## PROPOSED CHANGE RTS-74 TO DAEC TECHNICAL SPECIFICATIONS

Iowa Electric Light and Power Company

NG-83-0671

Revision 2 to Proposed Change RTS-124  
to the  
Duane Arnold Energy Center  
Technical Specifications

FIGURE 2.1-1

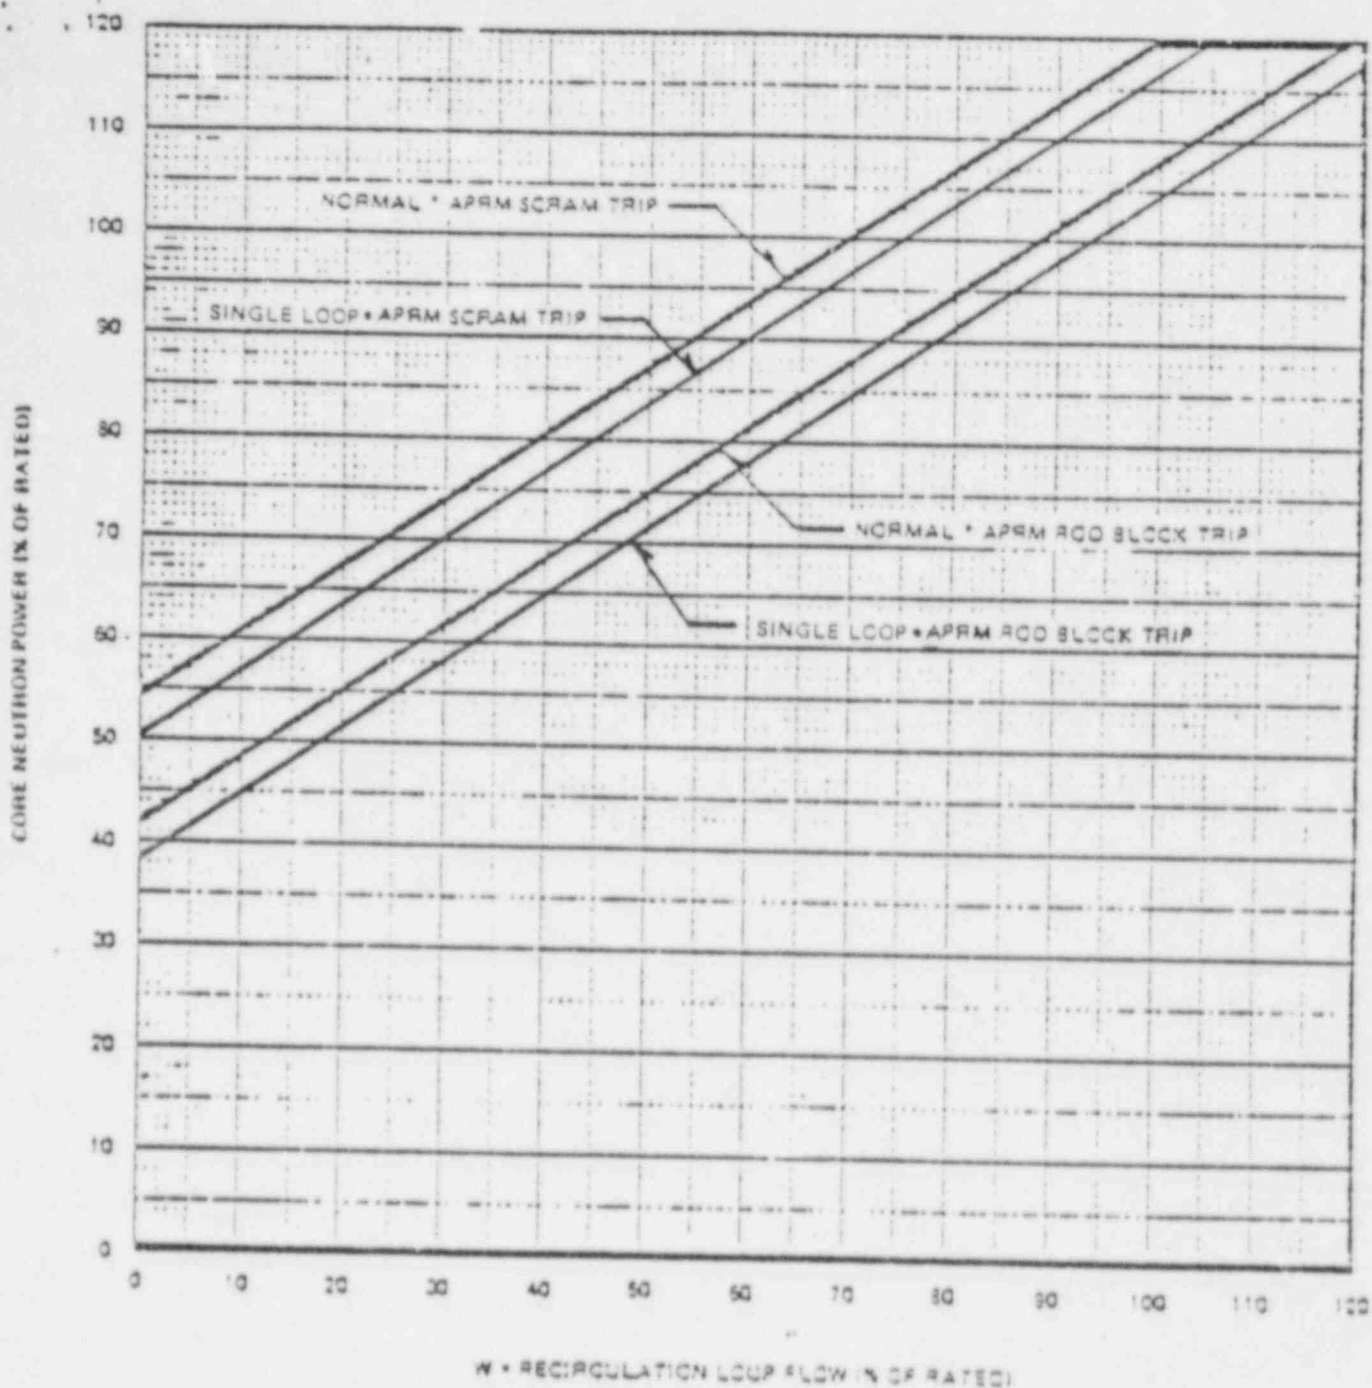
- 3) Add the APRM Flow-Biased Flux Scram and Rod Block Equations for SLO to Sections 2.1.A.1 and 2.1.A.3 respectively as well as Figure 2.1-1 and to Tables 3.1-1 and 3.2-C (pages 1.1-19, 3.1-3 and 3.2-16). Also add the SLO-modified Rod Block Monitor (RBM) equation to Table 3.2-C.

$$S \leq (0.66 W + 50.7)$$

with a maximum setpoint of 116.7 rated power at 100% rated recirculation flow or greater.

$$S \leq (0.66 W + 38.7)$$

TABLE 3.12-2

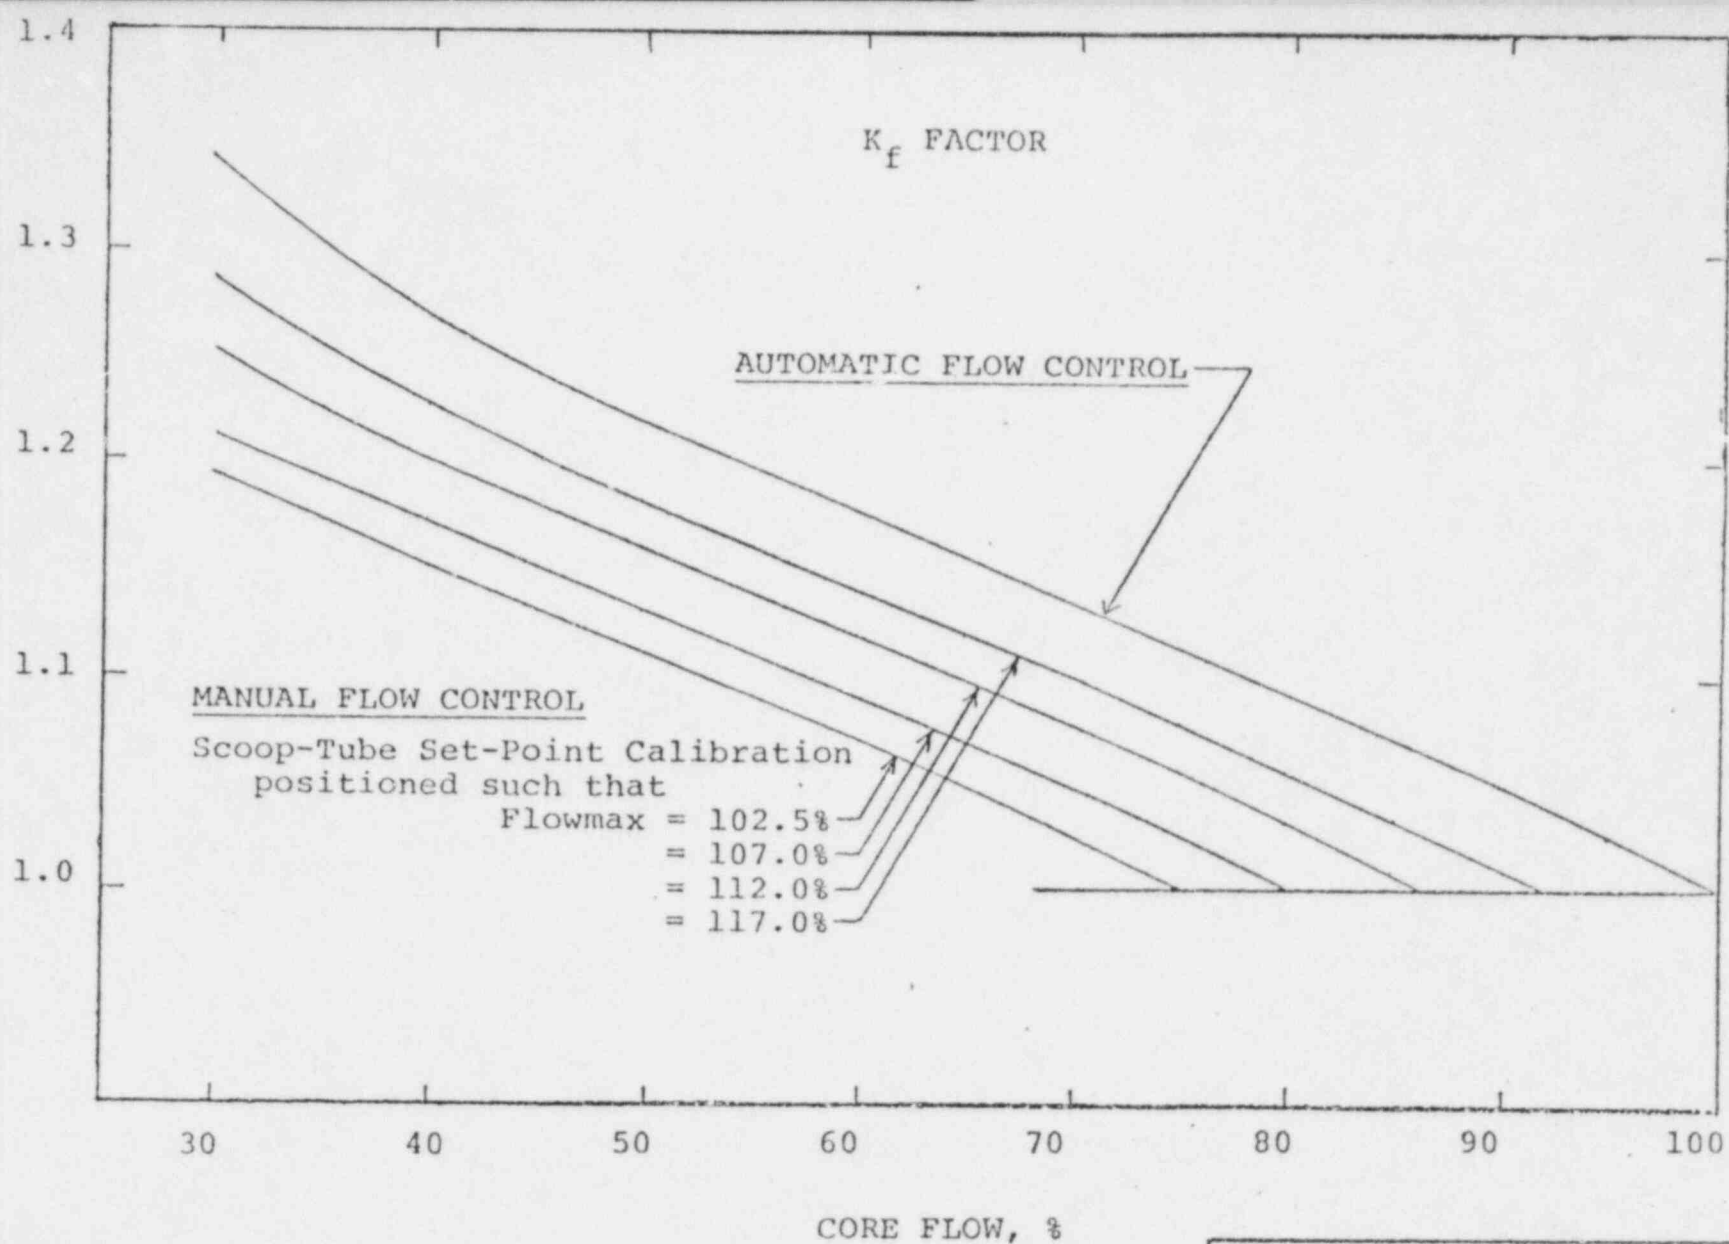
During reactor power operation MCPR for one or two recirculation loop operation shall be  $\geq$  values as indicated in Table 3.12-2. These values are multiplied by  $K_f$  which is shown in figure 3.12-1. Note that for one recirculation loop operation the MCPR limits at rated flow are 0.03 higher than the comparable two-loop values. If at any time during reactor power operation (one or two loop) it is determined by normal surveillance that the limiting value for MCPR is being exceeded, action shall then be initiated within 15 minutes to restore operation to within the prescribed limits. If the operating MCPR is not returned to within the prescribed limits within two hours, reduce reactor power to  $< 25\%$  of rated thermal power, or to such a power level that the limits are again being met, within the next 4 hours.

<u>Fuel Type</u>	<u>For two recirculation loop operation</u>	<u>For one recirculation loop operation</u>
8 x 8	1.25	1.28
8 x 8R/P8 x 8R	1.27	1.30

FIGURE 3.12-5

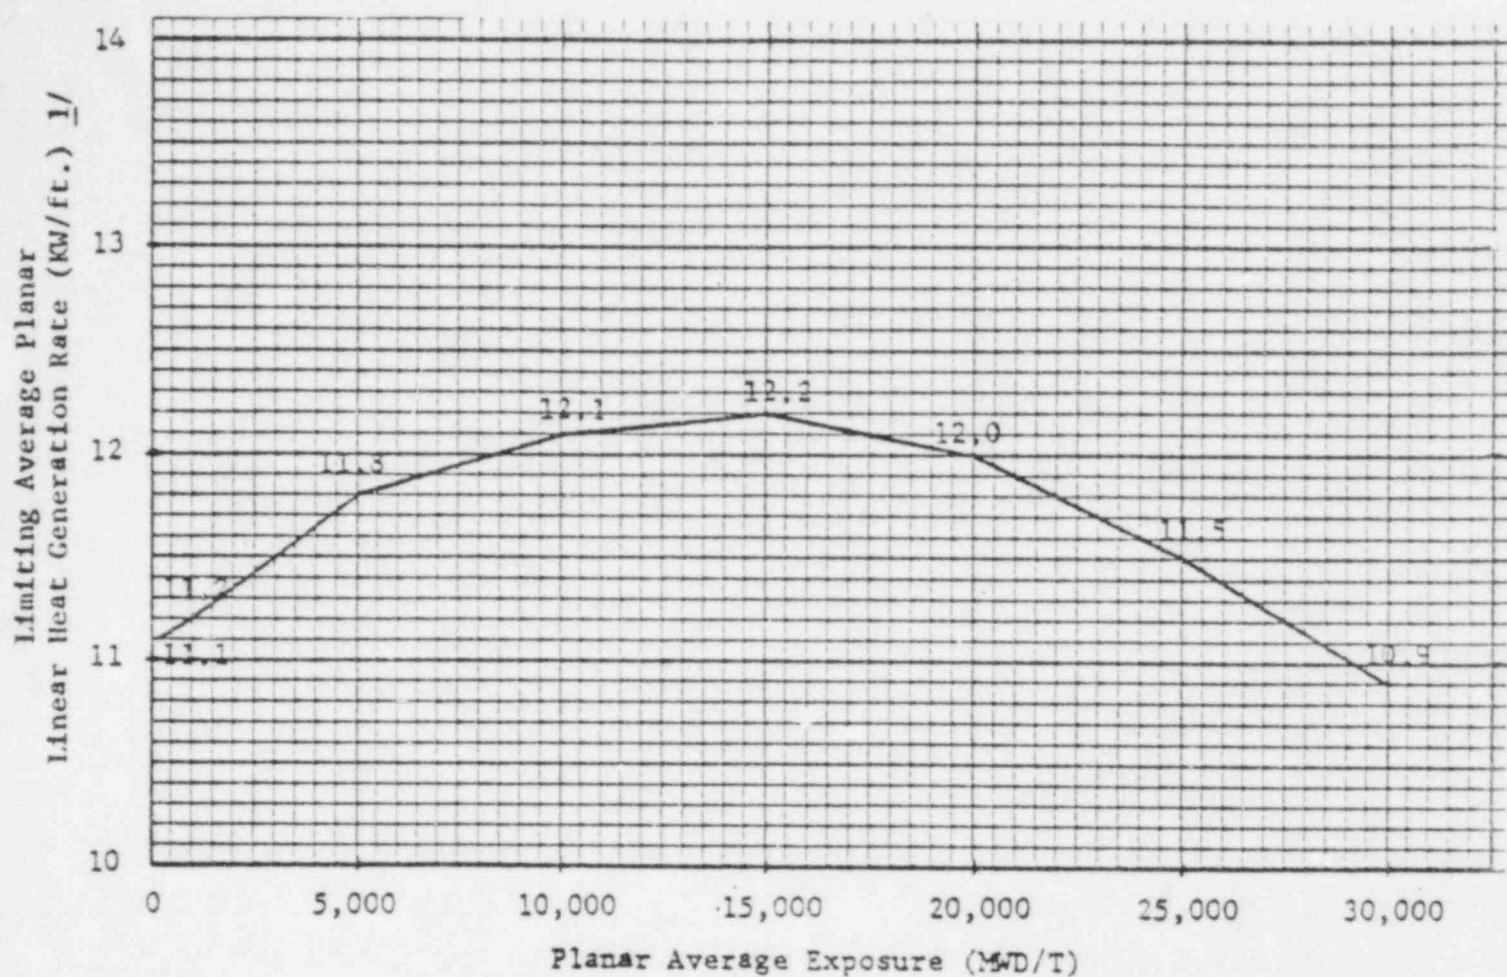
During reactor power operation, the actual MAPLHGR for each type of fuel as a function of average planar exposure shall not exceed the limiting value shown in Figs. 3.12-5, -6, -7, -8 and -9. For single-loop operation, the values in these curves are reduced by multiplying by 0.7. If at any time during reactor power operation (one or two loop) it is determined by normal surveillance that the limiting value for MAPLHGR (LAPLHGR) is being exceeded, action shall then be initiated within 15 minutes to restore operation to within the prescribed limits. If the MAPLHGR (LAPLHGR) is not returned to within the prescribed limits within 2 hours, reduce reactor power to  $< 25\%$  of rated thermal power, or to such a power level that the limits are again being met, within the next 4 hours.
